Proposed Residential Development, Lot No. 716 at DD216, Tai Mong Tsai, Sai Kung Report on the Review of Road Safety for New Development Access – Response to Comments

Kong Lid W1T 4BQ Company Proposed Residential Development, Lot No. 716 at DD216 Tai Mong Tsai, Sai Kung Report on the Review of Road Safety for New Development Access

Response to Comments on Traffic Impact Assessment Report

FIGURE 4A

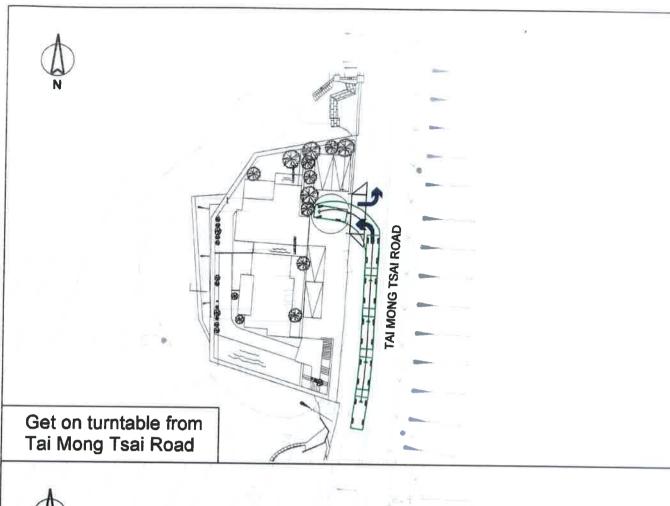
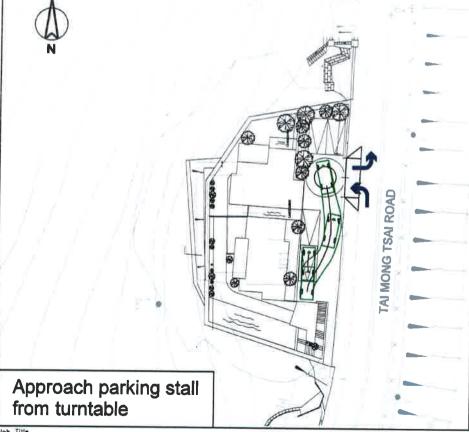
(b) The proposed installation of convex mirror on public road is considered not acceptable from traffic engineering viewpoint. Please do not recommend the convex mirror as one of the safety improvement measures.	The convex mirror has been removed in the revised improvement measures drawing. (Refers to attached Figure 5 (Rev 1))
(Para 3.3: please note that back-in/back-out movements of vehicles from/to the captioned development via the vehicular access point will not be permitted. In this regard, please elaborate on how the proposed turntable will be operated.	The swept path analysis for passenger car approach or leave the individual parking stall via the turntable are shown in Figures 4A and 4B.
